Our Ref: PL/26/0686
Your Ref:

8th July 2026

RE: PROPOSED WORKS TO 1NO. NORWAY SPRUCE AT ROMAN CATHOLIC CHURCH OF THE ENGLISH MARTYRS, LIEBENROOD ROAD, READING - T1 OF TREE PRESERVATION ORDER NUMBER 51/06.

Figure 1: 4no. branches within the first whorl to be removed back to source

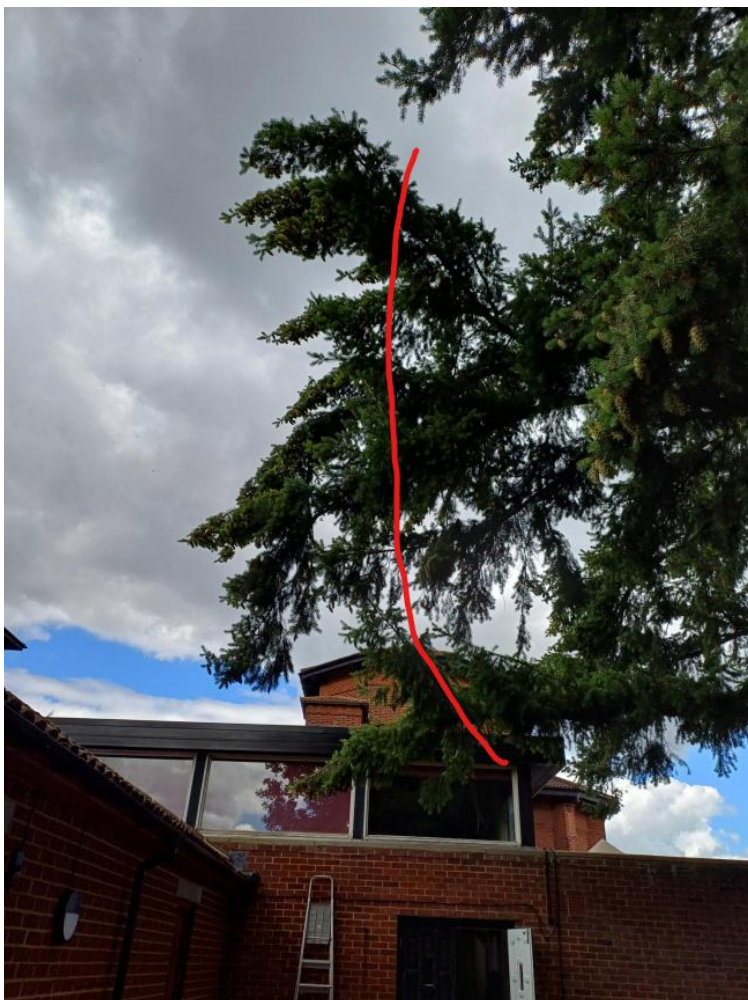
The four branches of the first whorl are proposed to be removed back to their source (main stem). Given the defects mentioned in your Tree Condition Survey, including the failed/broken branch and the splitting of timber in two others, this is considered reasonable. Removing these branches, along with the reductions discussed below, will hopefully reduce the likelihood of failure, similar to that experienced by one of the branches already. The other branch without any defects is growing low and close to the building, hence it's removal to create clearance is considered appropriate. It is best these

- Remove lower whorl of branches which includes of 1no. broken branch, 2no. split branches and 1no. branch with branch tips overhanging the building/parking area back to source, as shown in Figure 1 below;

Figure 3: tip reduction of lower branches on the northeast aspect by approximately 1.5m

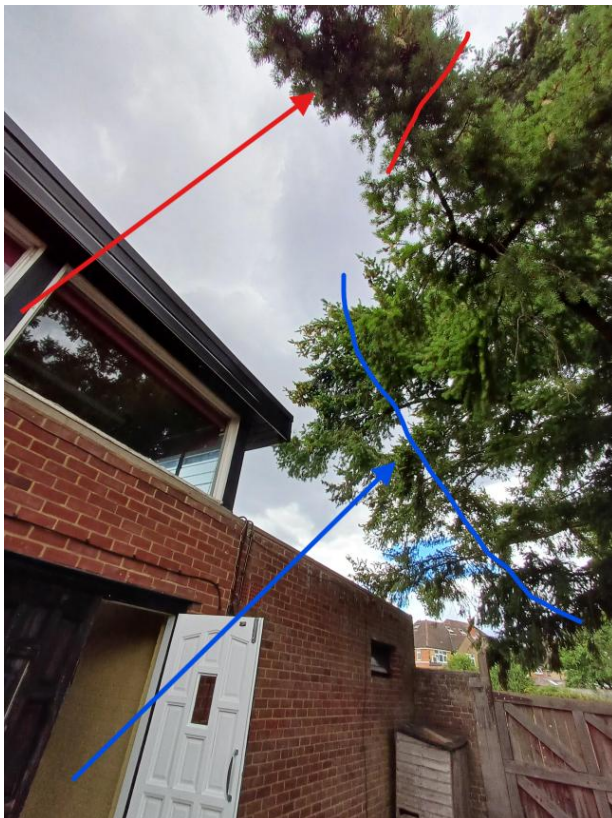
- Tip reduce lower branches on the northeast (see Figure 3 & 4) and northwest aspects (see Figure 4) by approximately 1.5m, ensuring no more than one third of the foliage is removed from each branch, leaving suitable growth points;
